Important Notices

TOSHIBA Microcontrollers 900 Family

Restriction on Use of 8-bit Timers

Datasheet Modifications: PWM Cycle of 8-bit Timers

Example when using PWM mode

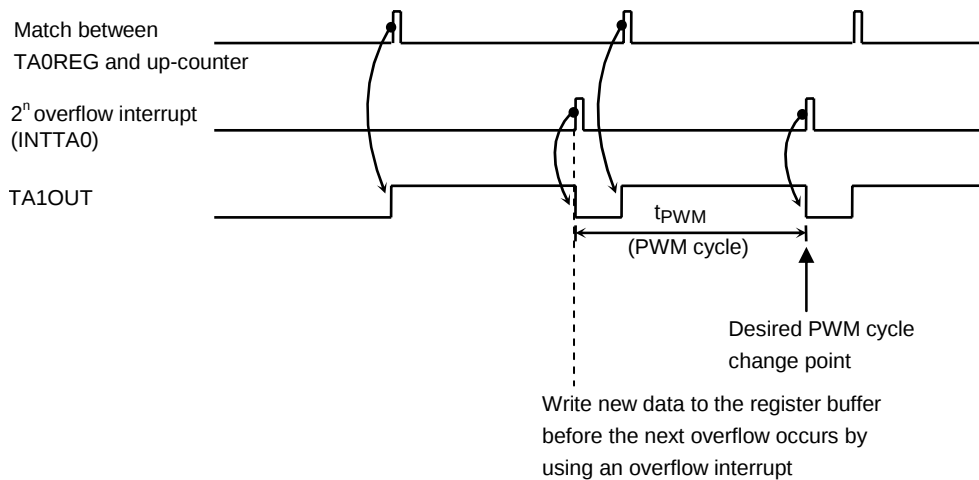
When the double buffer is enabled for an 8-bit timer in PWM or PPG mode, caution is required as explained below.

If new data is written to the register buffer immediately before an overflow occurs by a match between the timer register value and the up-counter value, the timer flip-flop may output an unexpected value.

For this reason, make sure that in PWM mode new data is written to the register buffer by six cycles ($f_{\text{sys}} \times 6$) before the next overflow occurs by using an overflow interrupt.

In the case of using PPG mode, make sure that new data is written to the register buffer by six cycles before the next cycle compare match occurs by using a cycle compare match interrupt.
